## **ADDENDUM NO. 2**

Date: May 23, 2018

**Project: Hiram Johnson HVAC Replacement**

SCALE: 1/8"=1'-0'

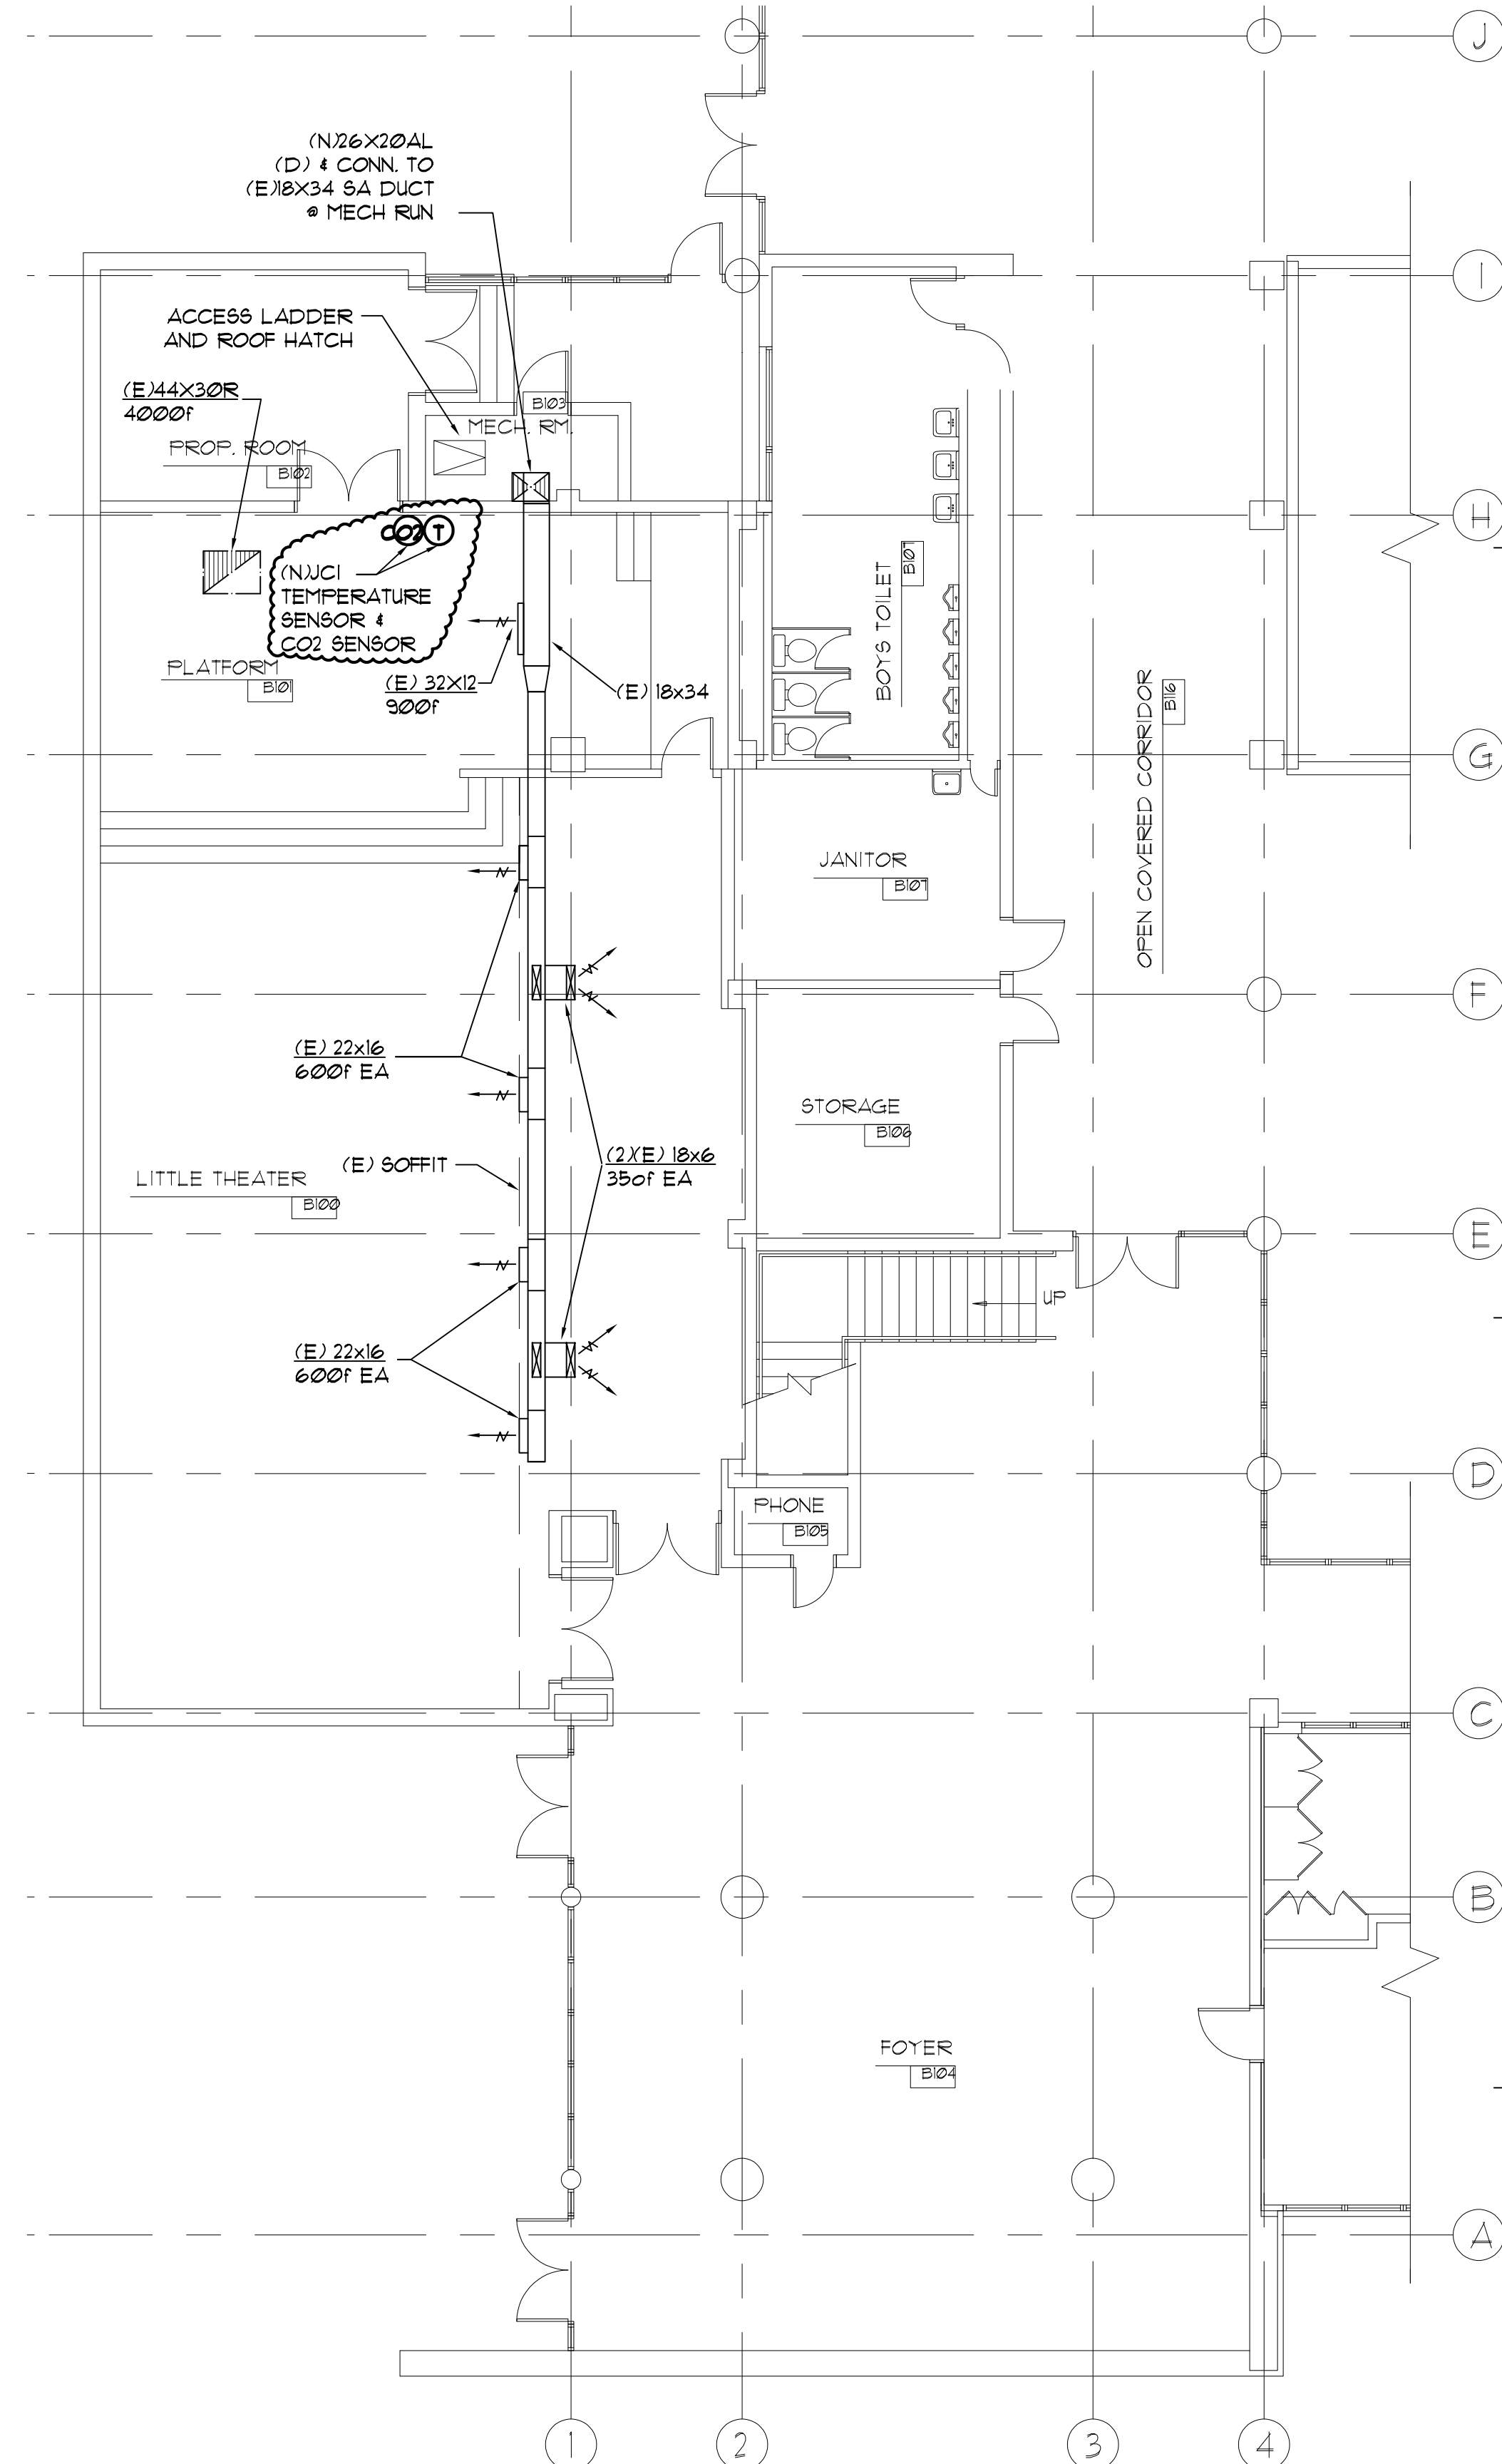
**Refer to Drawing M2.05**

**Note:** The drawing is updated to add the detail "C" showing the location of the new control valve location. Detail "B" updated to specify the linear for the ductwork on the roof.

**A** AIR CONDITIONING UNIT MOUNTING DETAIL

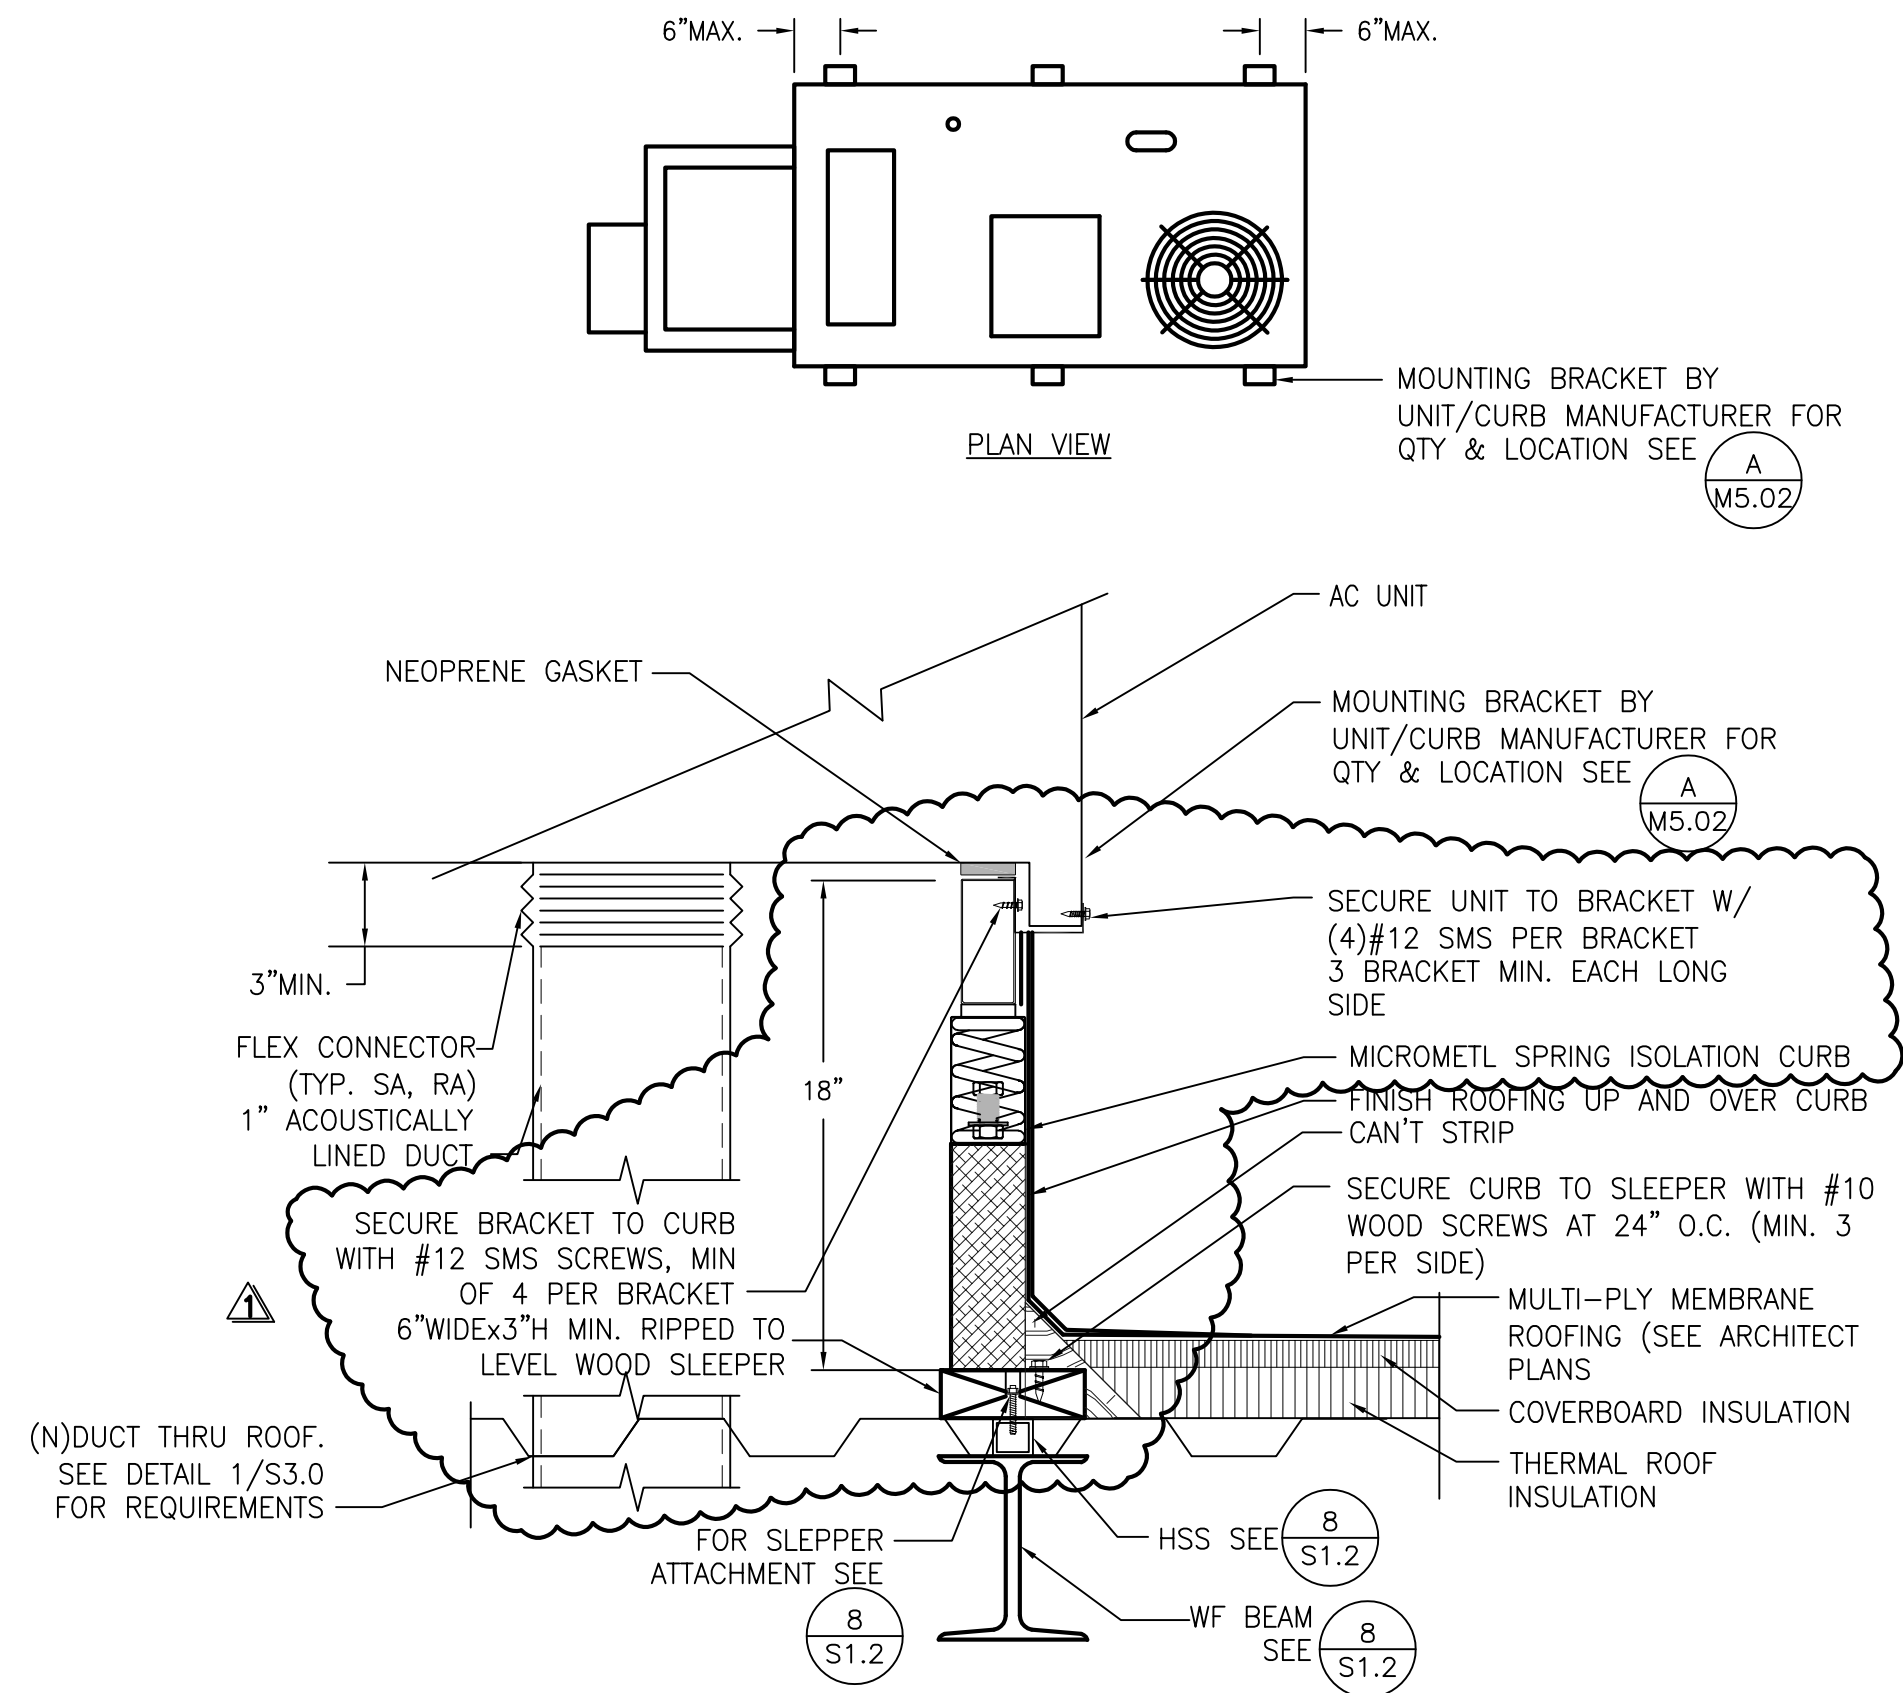
**Refer to Drawing M5.01**

**Note:** The detail "A" is updated to show the spring isolator curb for the new rooftop AC unit. Detail "B" is updated to clarify the spacing requirements.

Client Project Number:	Client Proj. #
Scale: As indicated	Sheet
Drawn By: Chris	<b>E1.01</b>
Checked By: Donny	
Issue Date: 4/17/18	
Revit Version: 2017

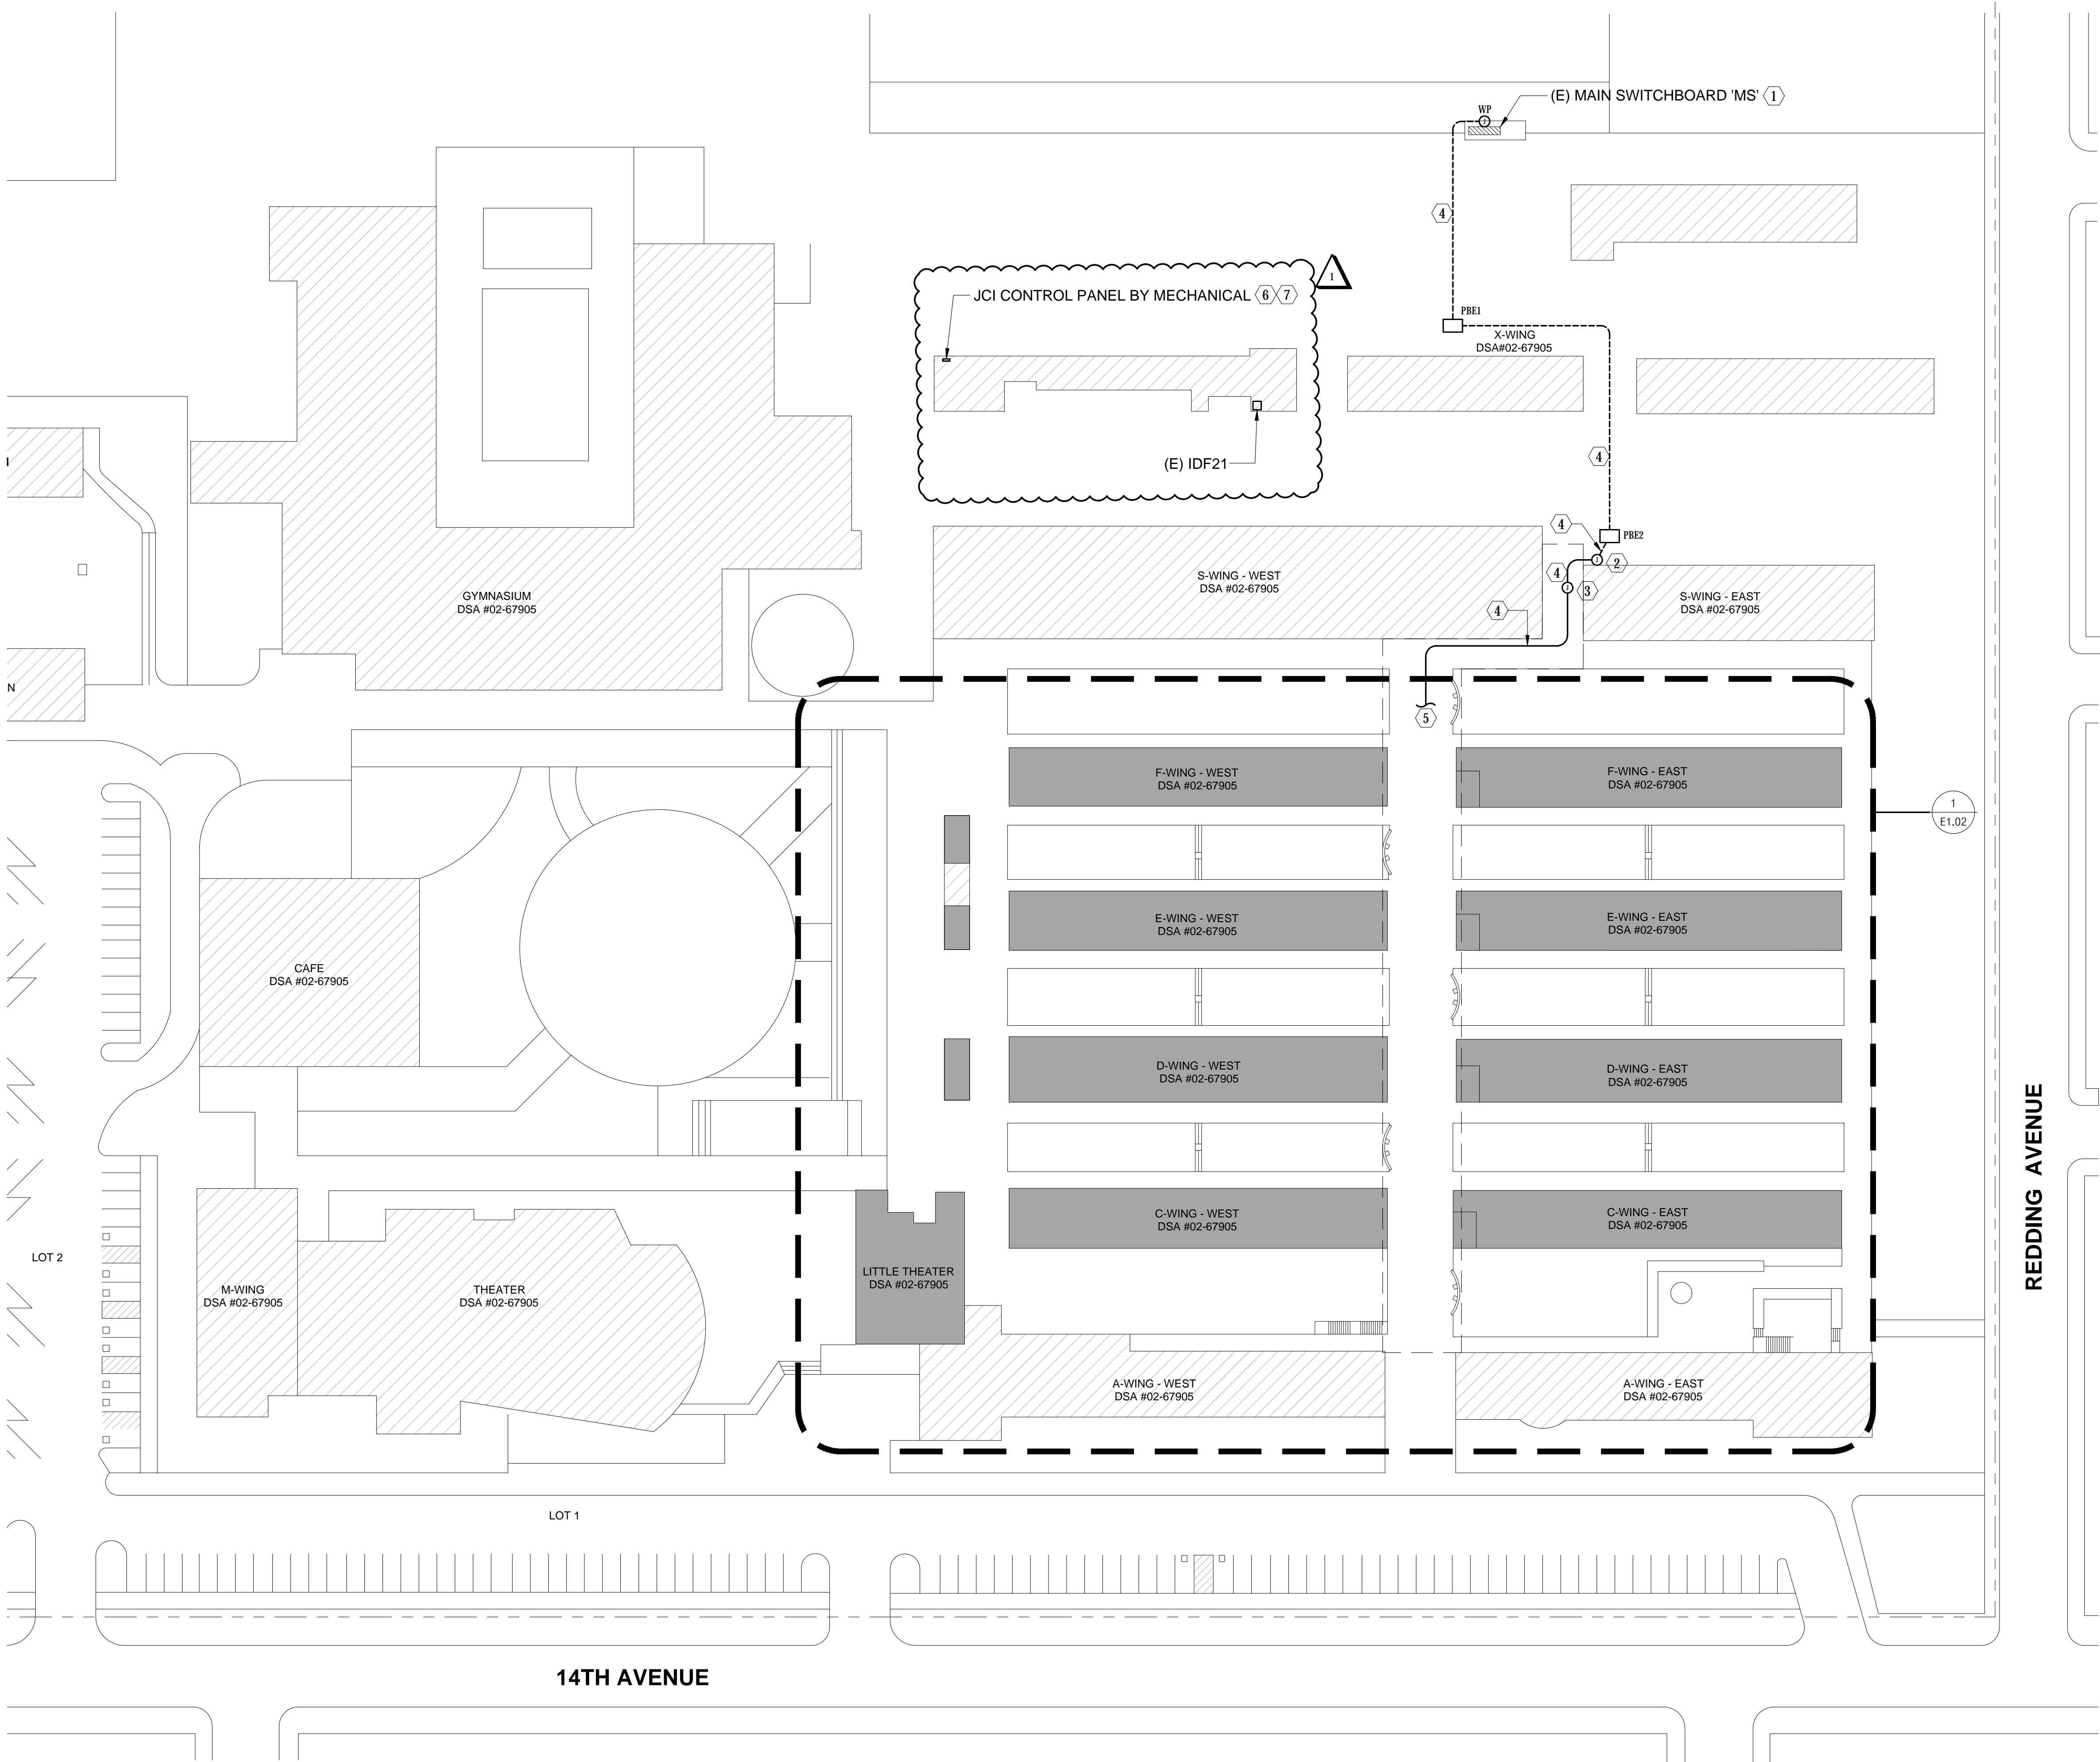
**Refer to Drawing Sheet E1.01**

**Note:** Added connection to a new mechanical controller.
